Access Compliance Report

Public Rights-of-Way

(Curb Ramps)

Intersection ID: 47384	Main Street: BRIDGEWALK_DR	Cross Street: ARDREY_KELL_RD	Location: NE
ADA ID: E48F0611B52C	Ramp Type: PerpDiag	Initial Pass/Fail: Fail	Overall Compliance: No
Severity Score: 37.5			
Codes/Mitigation Info/Possible Solution		Field Measurements/Component Compliance

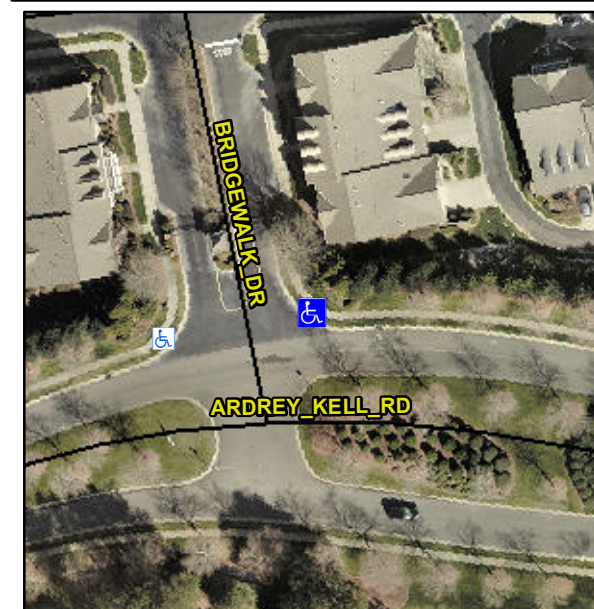
Not Found, R304.2.2, R304.5.3

Compliance	Description	Data	Compliance	Description	Data
N/A	Ramp Length (in)	47.5	No	Ramp Slope (%)	9.0
Yes	Ramp Width (in)	51.5	No	Ramp XSlope (%)	8.1
N/A	Flare Type LT	N/A	N/A	Flare Type RT	N/A
N/A	Flare Slope LT (%)	N/A	N/A	Flare Slope RT (%)	N/A
N/A	Flare Traversable LT?	N/A	N/A	Flare Traversable RT?	N/A
N/A	Landing Length (in)	N/A	N/A	DWS Provided?	N/A
N/A	Landing Width (in)	N/A	N/A	DWS Contrast?	N/A
N/A	Landing Slope (%)	N/A	N/A	DWS Length (in)	N/A
N/A	Landing X Slope (%)	N/A	N/A	DWS Full Width?	N/A
N/A	Landing Curb? (Y/N)	N/A	N/A	DWS Offset (in)	N/A
N/A	Shared Landing?	N/A			
N/A	Gutter Ponding?	N/A	N/A	Gutter Slope (%)	N/A
N/A	Gutter Lip Ht (in)	N/A	N/A	Gutter X Slope (%)	N/A
N/A	Painted X Walk1?	No	N/A	Painted X Walk2?	No
	X Walk 1 Direction	To W		X Walk 2 Direction	To S
N/A	X Walk 1 Width (in)	N/A	N/A	X Walk 2 Width (in)	N/A
	X Walk 1 Slope (%)	5.5		X Walk 2 Slope (%)	1.3
	X Walk 1 X Slope (%)	1.8		X Walk 2 X Slope (%)	6.8

Remove & Replace Curb Ramp With Two New Directional Ramps or Equivalent.
